RENESAS TECHNICAL UPDATE

Category	MPU/MCU	Document No.	TN-SH7-A744A/E	Rev.	1.00	
Title	Correction of errors in the SH	Information Category	Technical Notification			
		0.				
Applicable Product	SH7280 Group	Reference Document	SH7280 Group Hardware Manual Rev1.00 REJ09B0393-0100			
This undato i	is to inform you of corrections to	orrors in the bardware	manual for the app	licable products indicate	ad above

• The following amendments have been made to the figure 16.12, Sample Flowchart for Receiving Serial Data (1) on page 801 in section 16, Serial Communication Interface (SCI).

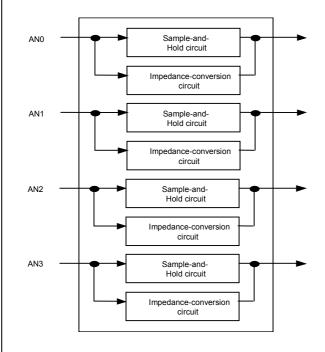
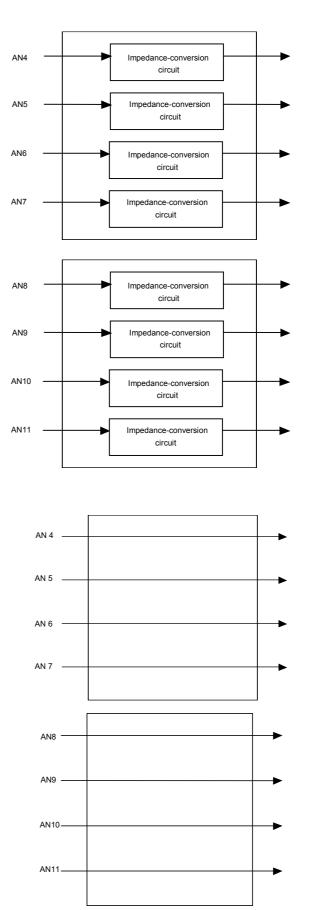
[Before change]

Set the CKE1 and CKE0 bits in SCSCR (TE and RE bits are 0).

[After change]

Read the receive data register (SCRDR) and clear the RDRF flag in SCSSR to 0.

The following amendments have been made to the figure 20.1, Block Diagram of A/D Converter on page 973 in section 20, A/D Converter (ADC).

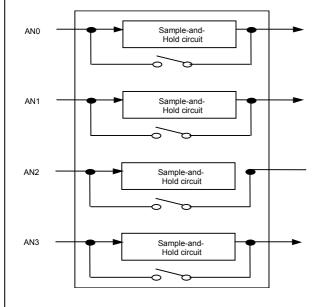
[Before change]

[After change]
